Product Change Notification

(Notification – P2007039-FUT)

(MCP-AC-20-0006)

This notification announces the following assembly changes for selected RL78 devices in the HWQFN package. Please see the Appendix for additional details on all changes.

Appendix E: 4x4mm 24pin HWQFN Package Drawing

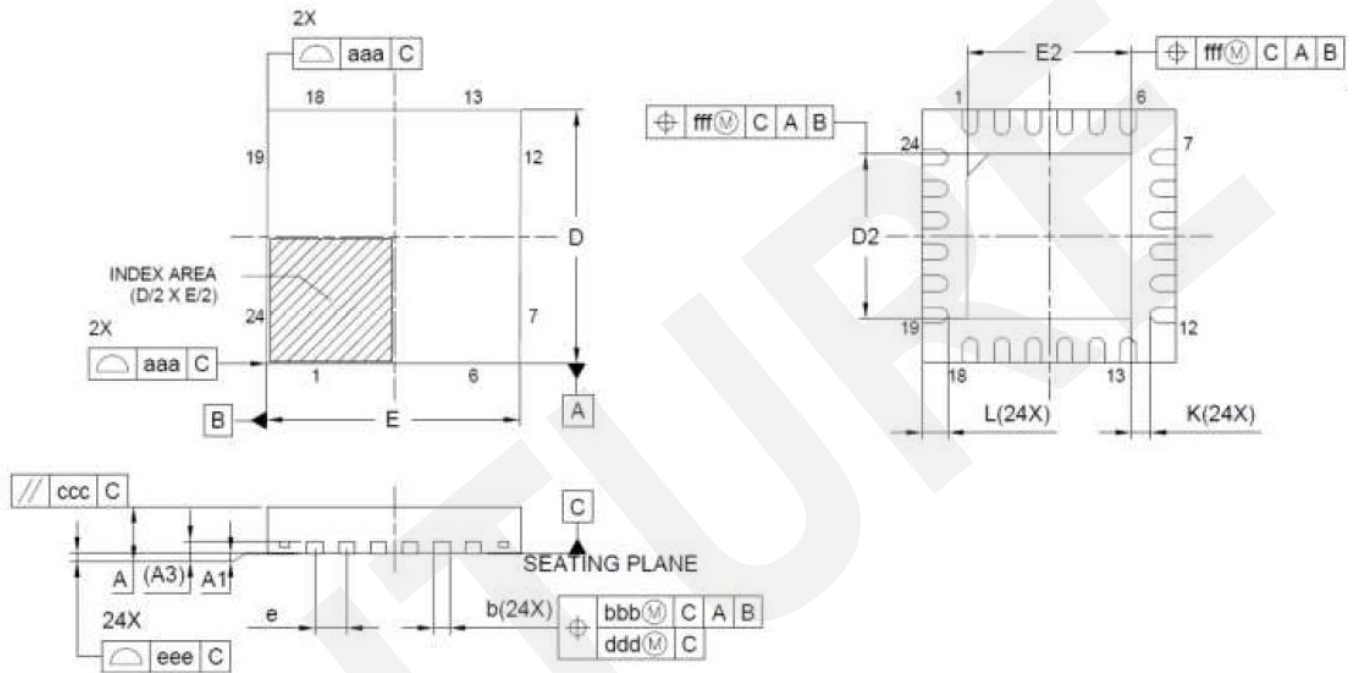
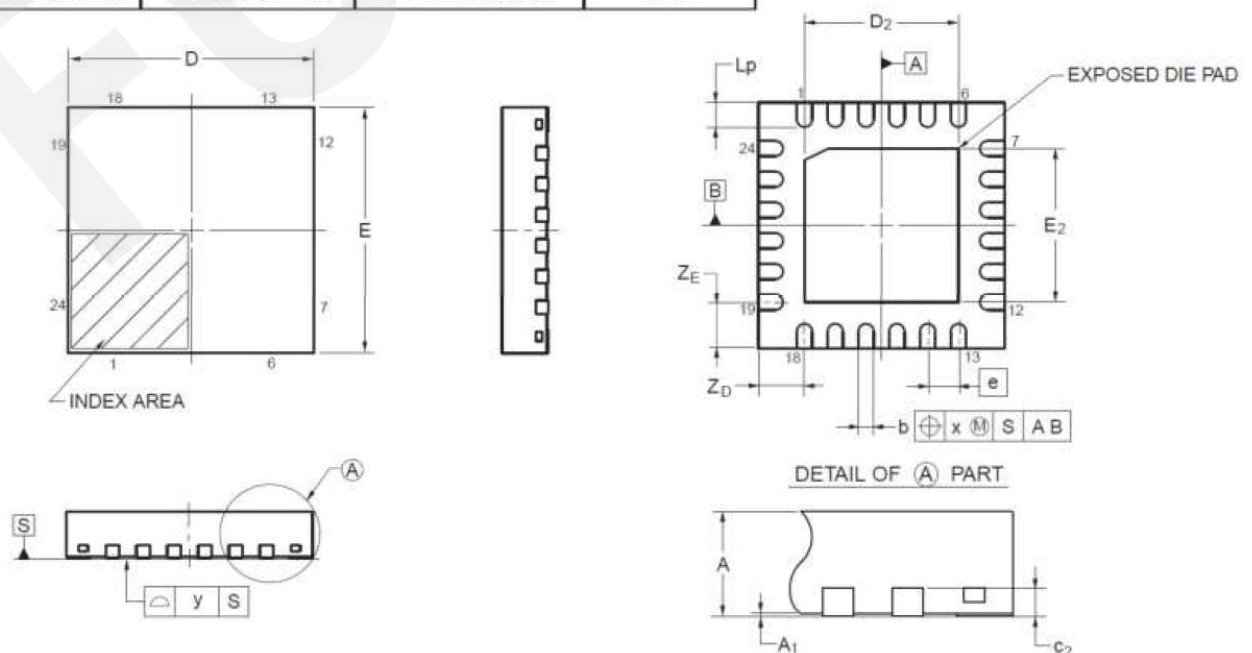
Dimension Comparison (JEDEC notation used instead of the conventional notation.)

New Symbol	4x4mm 24pin HWQFN			Current Symbol	4x4mm 24pin HWQFN		
	Dimension in Millimeters				Dimension in Millimeters		
	Min	Nom	Max		Min	Nom	Max
A	-	-	0.80	A	-	-	0.80
A1	0.00	0.02	0.05	A1	0.00	-	-
A3	0.203 REF.			C2	0.15	0.20	0.25
b	0.18	0.25	0.30	b	0.18	0.25	0.30
D	4.00 BSC			E	3.95	4.00	4.05
E	4.00 BSC			D	3.95	4.00	4.05
e	0.50 BSC			e	-	0.50	-
L	0.35	0.40	0.45	Lp	0.30	0.40	0.50
K	0.20	-	-	-	-	-	-
D2	2.55	2.60	2.65	E2	-	2.50	-
E2	2.55	2.60	2.65	D2	-	2.50	-
-	-	-	-	ZD	-	0.75	-
-	-	-	-	ZE	-	0.75	-
aaa	0.15			-	-	-	-
bbb	0.10			x	-	-	0.05
ccc	0.10			-	-	-	-
ddd	0.05			-	-	-	-
eee	0.08			y	-	-	0.05
fff	0.10			-	-	-	-

Appendix F: 5x5mm 32pin HWQFN Package Drawing

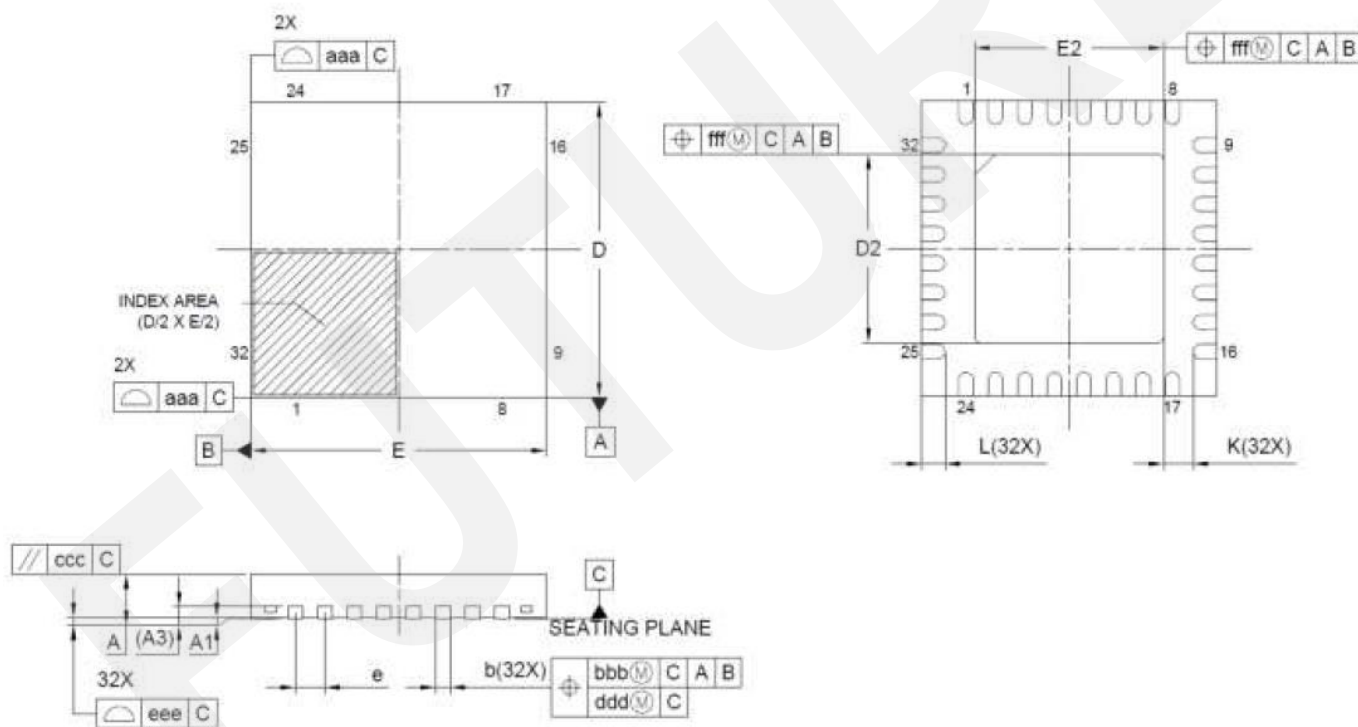
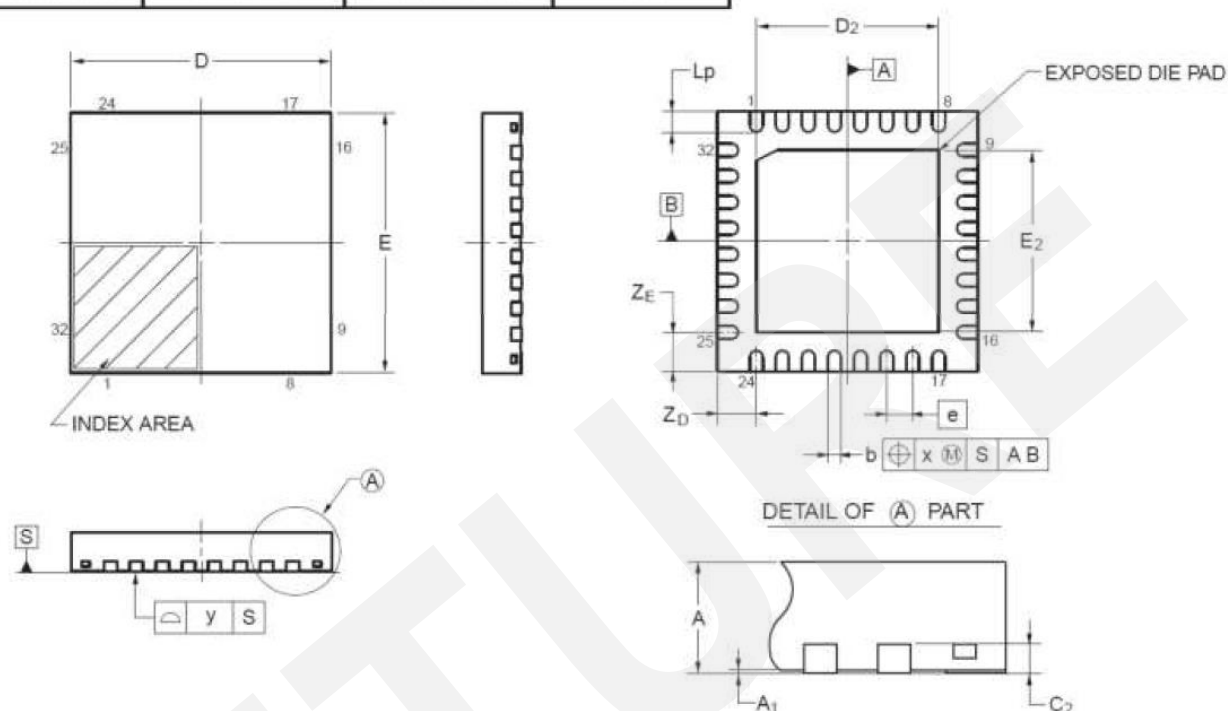
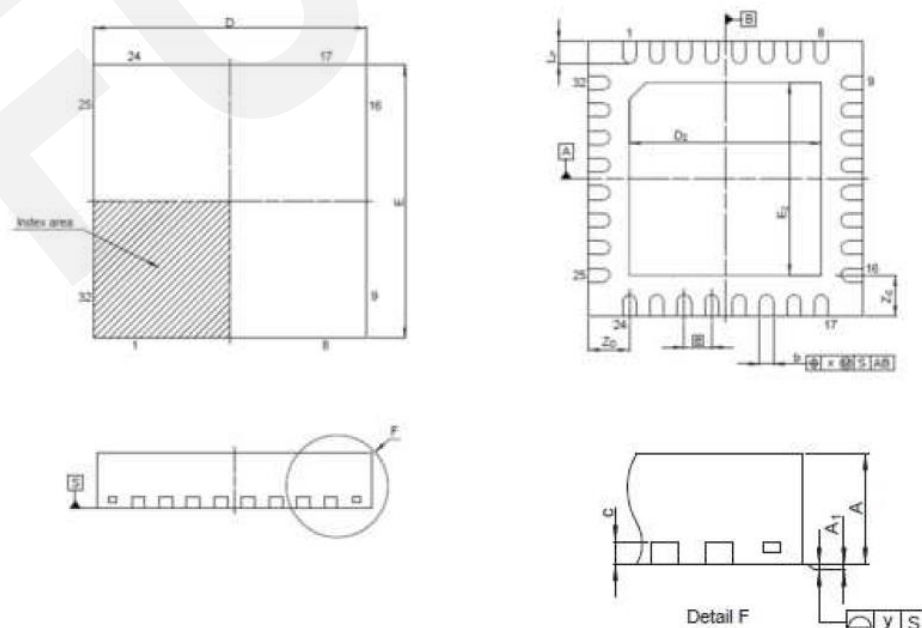
Dimension Comparison (JEDEC notation used instead of the conventional notation.)

New Symbol	5x5mm 32pin HWQFN PWQN0032KE-A			Current Symbol	Kumamoto : 5x5mm 32pin HWQFN PWQN0032KB-A			Hakodate : 5x5mm 32pin HWQFN PVQN0032KF-A		
	Dimension in Millimeters				Dimension in Millimeters			Dimension in Millimeters		
	Min	Nom	Max		Min	Nom	Max	Min	Nom	Max
A	-	-	0.80	A	-	-	0.80	-	-	1.00
A1	0.00	0.02	0.05	A1	0.00	-	-	0.00	-	-
A3	0.203 REF.			C2	0.15	0.20	0.25	-	0.20	-
b	0.18	0.25	0.30	b	0.18	0.25	0.30	0.20	0.25	0.30
D	5.00 BSC			E	4.95	5.00	5.05	4.90	5.00	5.10
E	5.00 BSC			D	4.95	5.00	5.05	4.90	5.00	5.10
e	0.50 BSC			e	-	0.50	-	-	0.50	-
L	0.35	0.40	0.45	Lp	0.30	0.40	0.50	0.30	0.40	0.50
K	0.20	-	-	-	-	-	-	-	-	-
D2	3.15	3.20	3.25	E2	-	3.50	-	-	3.50	-
E2	3.15	3.20	3.25	D2	-	3.50	-	-	3.50	-

-	-	-	-	ZD	-	0.75	-	-	0.75	-
-	-	-	-	ZE	-	0.75	-	-	0.75	-
aaa	0.15			-	-	-	-	-	-	-
bbb	0.10			x	-	-	0.05	-	-	0.05
ccc	0.10			-	-	-	-	-	-	-
ddd	0.05			-	-	-	-	-	-	-
eee	0.08			y	-	-	0.05	-	-	0.05
fff	0.10			-	-	-	-	-	-	-

Appendix G: 6x6mm 40pin HWQFN Package Drawing

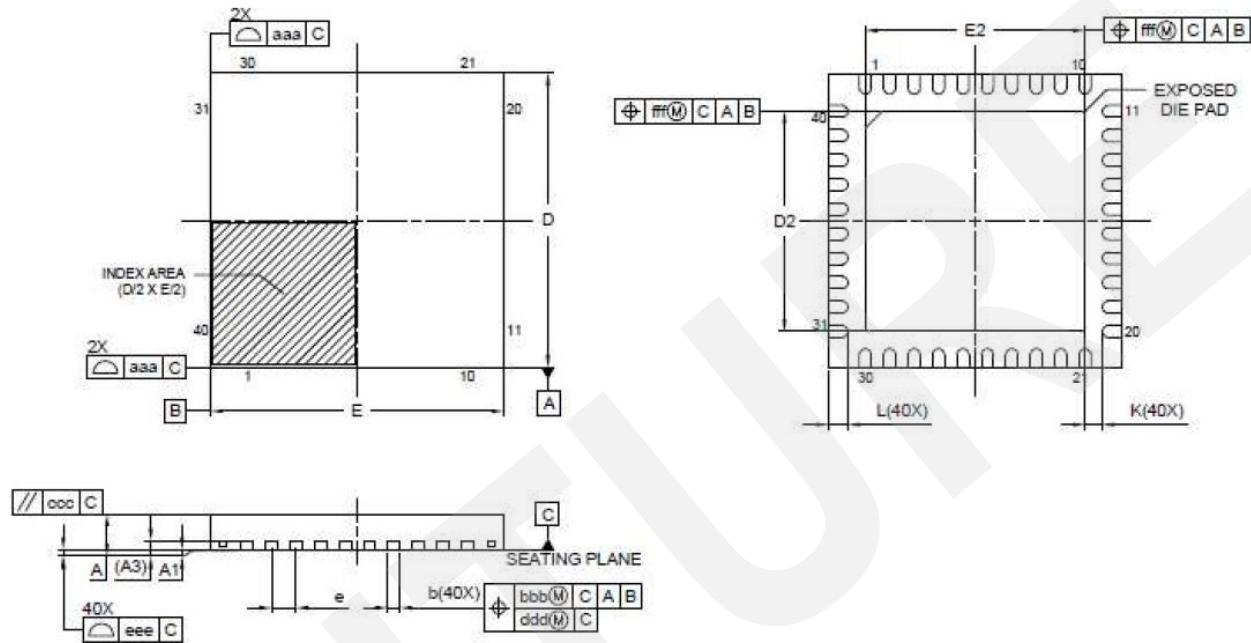
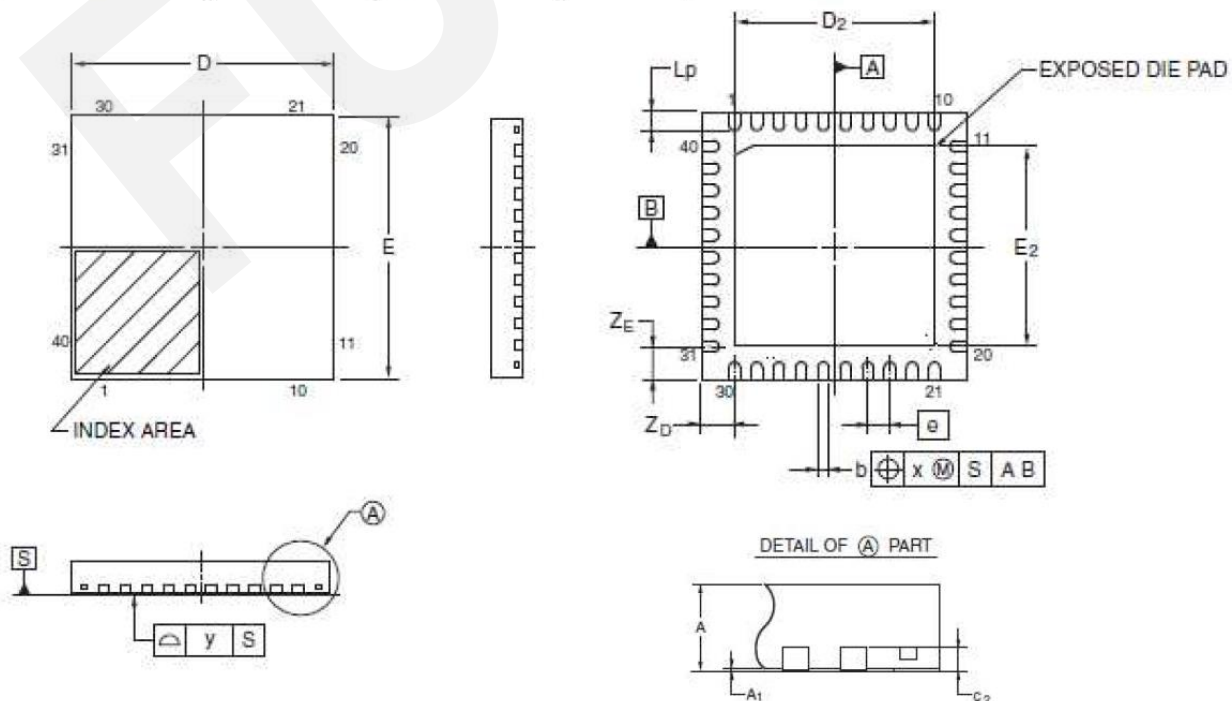
Dimension Comparison (JEDEC notation used instead of the conventional notation.)

New Symbol	6x6mm 40pin HWQFN			Current Symbol	6x6mm 40pin HWQFN		
	Dimension in Millimeters				Dimension in Millimeters		
	Min	Nom	Max		Min	Nom	Max
A	-	-	0.80	A	-	-	0.80
A1	0.00	0.02	0.05	A1	0.00	-	-
A3	0.203 REF.			C2	0.15	0.20	0.25
b	0.18	0.25	0.30	b	0.18	0.25	0.30
D	6.00 BSC			E	5.95	6.00	6.05
E	6.00 BSC			D	5.95	6.00	6.05
e	0.50 BSC			e	-	0.50	-
L	0.30	0.40	0.50	Lp	0.30	0.40	0.50
K	0.20	-	-	-	-	-	-
D2	4.45	4.50	4.55	E2	-	4.50	-
E2	4.45	4.50	4.55	D2	-	4.50	-
-	-	-	-	ZD	-	0.75	-
-	-	-	-	ZE	-	0.75	-
aaa	0.15			-	-	-	-
bbb	0.10			x	-	-	0.05
ccc	0.10			-	-	-	-
ddd	0.05			-	-	-	-
eee	0.08			y	-	-	0.05
fff	0.10			-	-	-	-

Appendix I: 8x8mm 64pin HWQFN Package Drawing

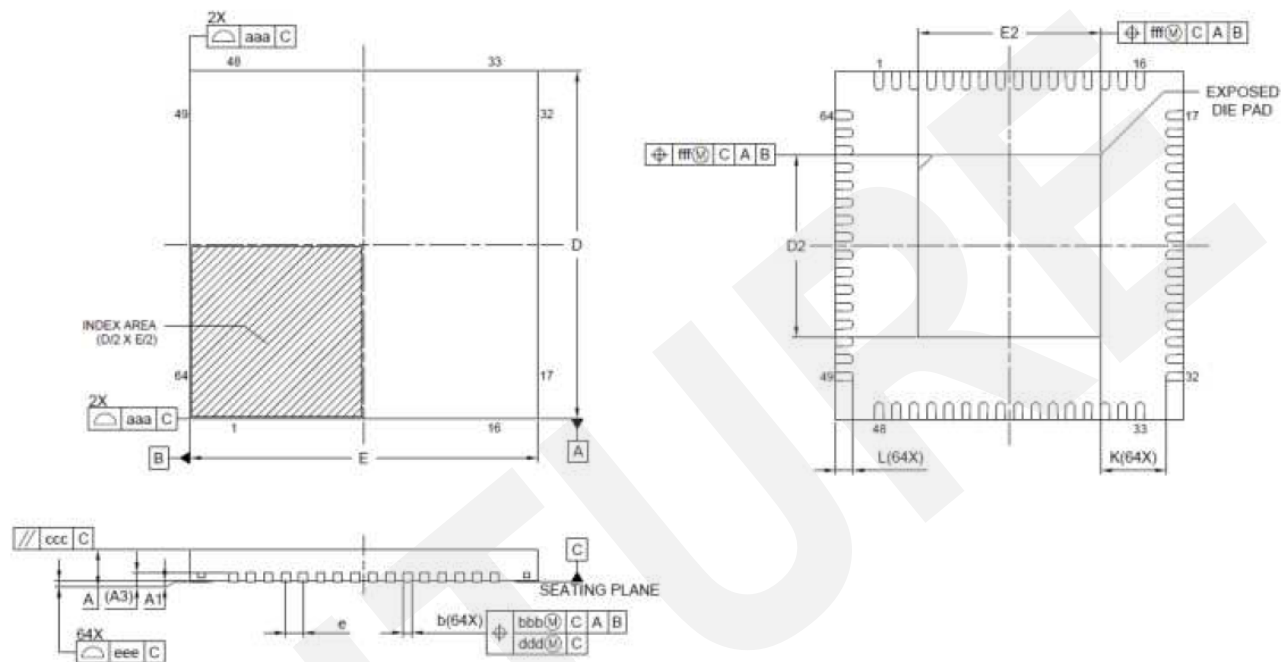
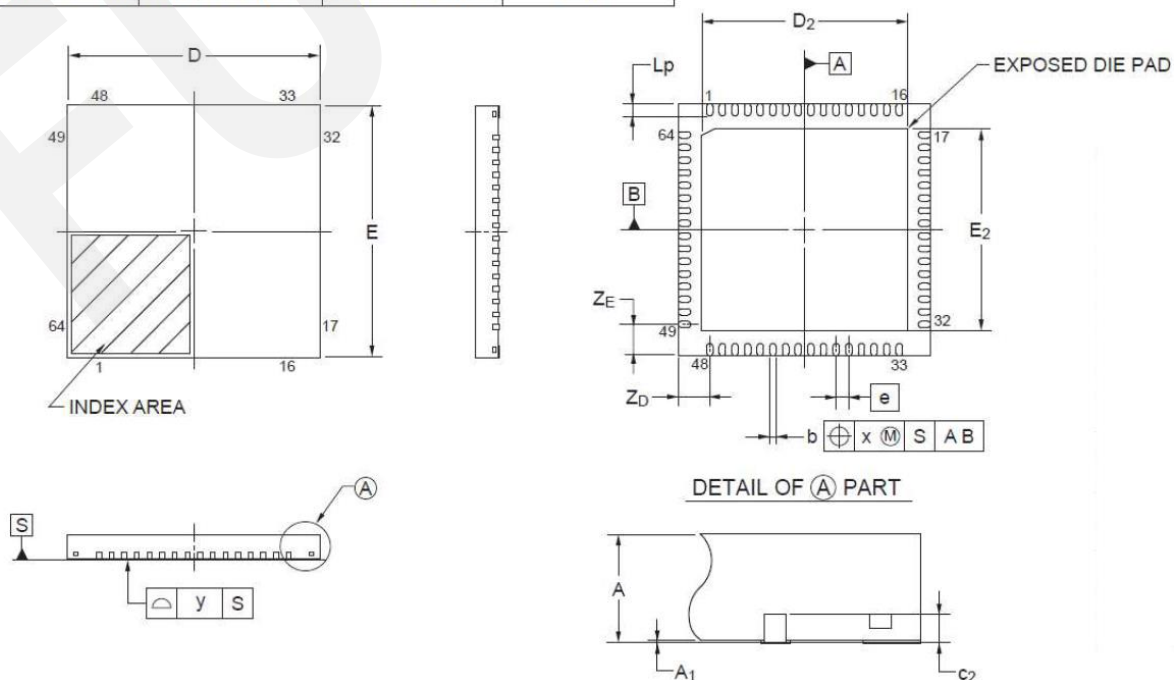
Dimension Comparison (JEDEC notation used instead of the conventional notation.)

New Symbol	8x8mm 64pin HWQFN PWQN0064??-A			Current Symbol	8x8mm 64pin HWQFN PWQN0064LA-A		
	Dimension in Millimeters				Dimension in Millimeters		
	Min	Nom	Max		Min	Nom	Max
A	-	-	0.80	A	-	-	0.80
A1	0.00	0.02	0.05	A1	0.00	-	-
A3	0.203 REF.			C2	0.15	0.20	0.25
b	0.20	0.25	0.30	b	0.18	0.25	0.30
D	8.00 BSC			E	7.95	8.00	8.05
E	8.00 BSC			D	7.95	8.00	8.05
e	0.40 BSC			e	-	0.40	-
L	0.30	0.40	0.50	Lp	0.30	0.40	0.50
K	0.20	-	-	-	-	-	-
D2	4.15	4.20	4.25	E2	-	6.50	-
E2	4.15	4.20	4.25	D2	-	6.50	-
-	-	-	-	ZD	-	1.00	-
-	-	-	-	ZE	-	1.00	-
aaa	0.10			-	-	-	-
bbb	0.07			x	-	-	0.05
ccc	0.10			-	-	-	-
ddd	0.05			-	-	-	-
eee	0.08			y	-	-	0.05
fff	0.10			-	-	-	-

Appendix L: Package Structure Image

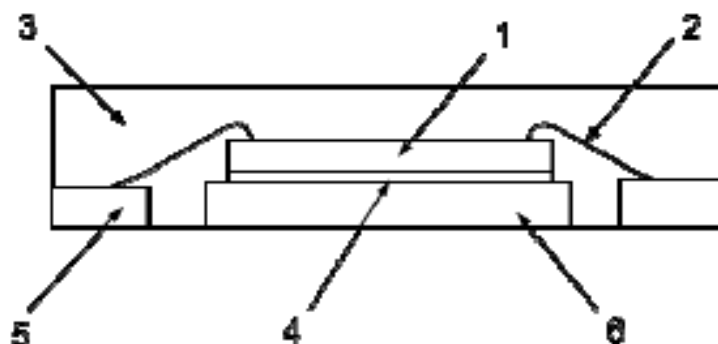
The materials are different because they use materials certified at the site, but the structure is equivalent.

Appendix M: Packing Specifications Change (Tray Order)

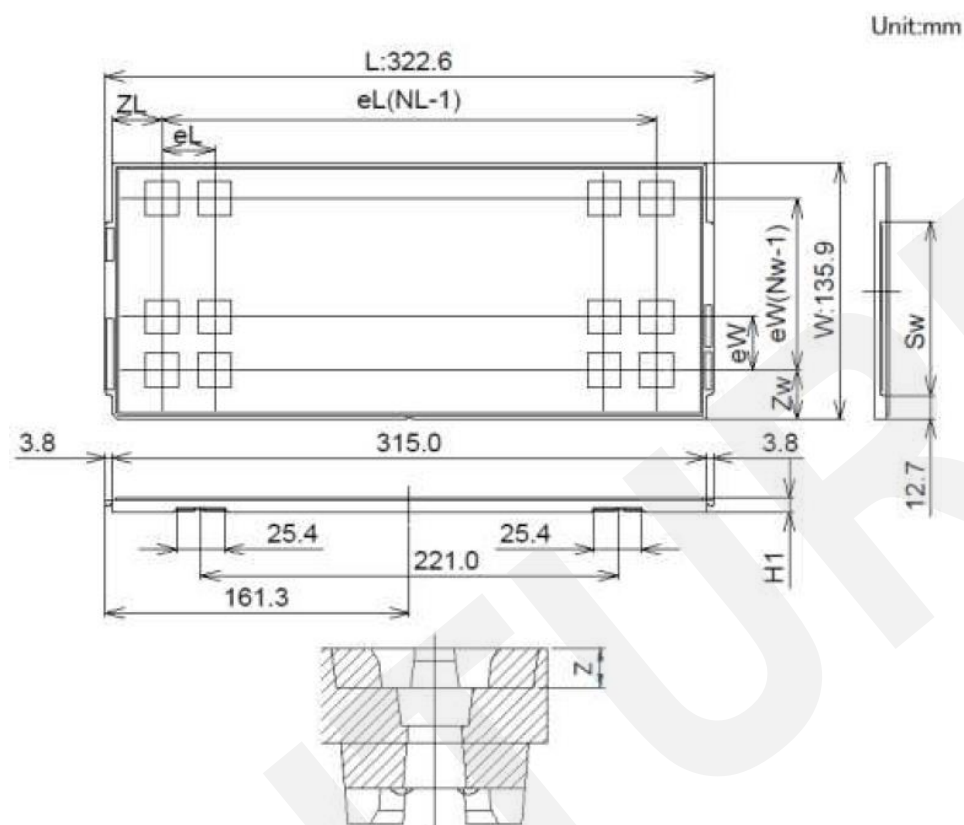
Assembly site	Order of Devices
New	
Current

Appendix N: Packing Specifications Change for 4mm×4mm 24pin HWQFN Tray

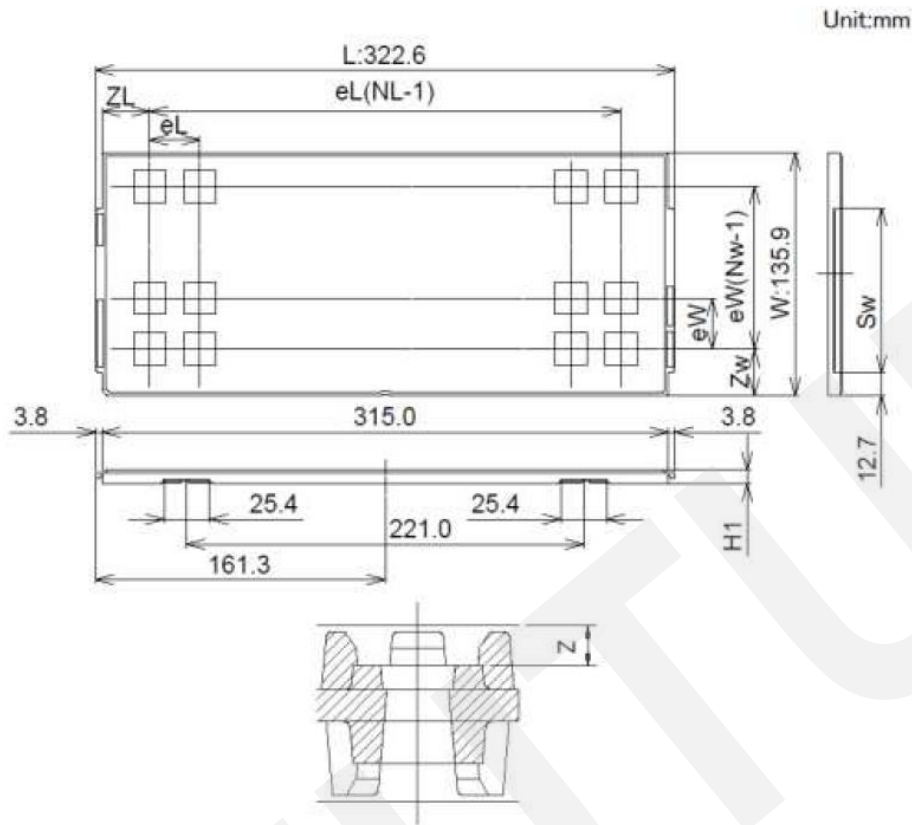
Tray Code		New	Current
		EAM040401-10	QJ-041 Rev.A
Position dimension of cells	Z	1.55	1.425
	Zw	8.15	8.15
	ZL	7.90	7.90
	eW	9.20	9.20
	eL	8.80	8.80
	Sw	92.10	92.10
Thickness (mm)	H1	7.62	7.62
Number of cells	Nw	14	14
	NL	35	35
Maximum storage pcs IC/Tray		490	490
Maximum storage pcs IC/Inner box		3920	3920
Material		Carbon PPE	Carbon PPE
Heat resistant temperature		135°C MAX	135°C MAX
JEDEC or Custom		JEDEC	JEDEC
Surface resistance		Less than $1 \times 10^{11} \Omega/\square$	Less than $1 \times 10^{11} \Omega/\square$

Appendix O: Packing Specifications Change for 5mm×5mm 32pin HWQFN Tray

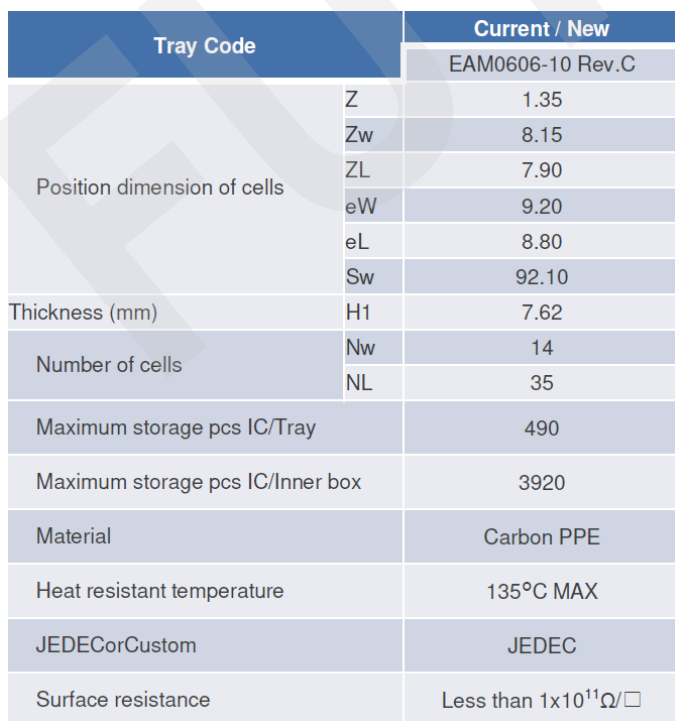
Tray Code		New	Current
		EAM050501-10	Rev.B EAM050503-10
Position dimension of cells	Z	1.75	1.50
	Zw	8.15	8.15
	ZL	7.90	7.90
	eW	9.20	9.20
	eL	8.80	8.80
	Sw	92.10	92.10
Thickness (mm)	H1	7.62	7.62
Number of cells	Nw	14	14
	NL	35	35
Maximum storage pcs IC/Tray		490	490
Maximum storage pcs IC/Inner box		3920	3920
Material		Carbon PPE	Carbon PPE
Heat resistant temperature		135°C MAX	135°C MAX
JEDECorCustom		JEDEC	JEDEC
Surface resistance		Less than $1 \times 10^{11} \Omega/\square$	Less than $1 \times 10^{11} \Omega/\square$
